SAFETY RECALL

SC326

Subject: Steering Shaft Pinch Bolt and Locknut Replacement — GU7 and CHU Models

Figure 1 — Steering Shaft Pinch Bolt and Locknut

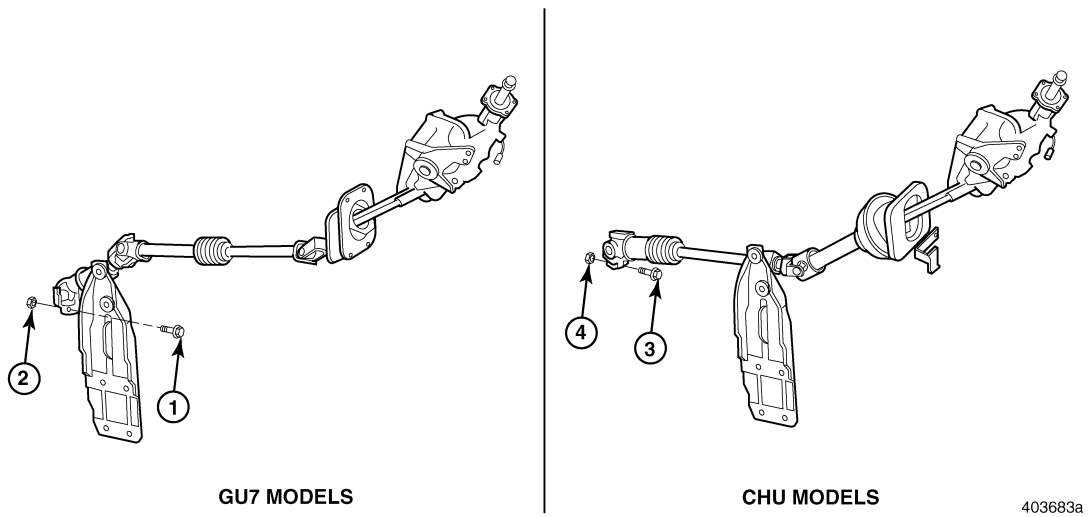
On certain GU7 and CHU model chassis manufactured between November 14, 2006 and May 22, 2007, it has been determined that the locking feature was omitted during the manufacturing process of the locknut used with the pinch bolt which retains the steering shaft to the steering gear input shaft. Should this nut come loose, the possibility exists for the steering shaft to separate. Approximately 1,072 GU7 and CHU models are affected by this campaign. A list of affected vehicles has been sent to all applicable dealers.

On GU models, metric hardware (10 mm x 1.5) was used for the steering shaft pinch bolt and locknut. This campaign is replacing the metric hardware on GU models with 7/16-20 UNF hardware.

1. Secure the chassis for service, apply the parking brakes and block the wheels to prevent the vehicle from moving.
2. Open the hood.
3. Remove the existing pinch bolt and locknut from the universal joint at the steering shaft-to-steering gear connection (refer to figure 1).

4. Install a new pinch bolt and locknut. Refer to the chart below for the pinch bolt and locknut part numbers.

5. Tighten the pinch bolt locknut proper specifications as follows:
 - 7/16" pinch bolt — 95 N•m (70 lb-ft)
 - M10 pinch bolt — 60 N•m (44 lb-ft)
6. Mark the new nut with a yellow paint stick to signify that the pinch bolt and locknut have been replaced.
7. Return the vehicle to service.
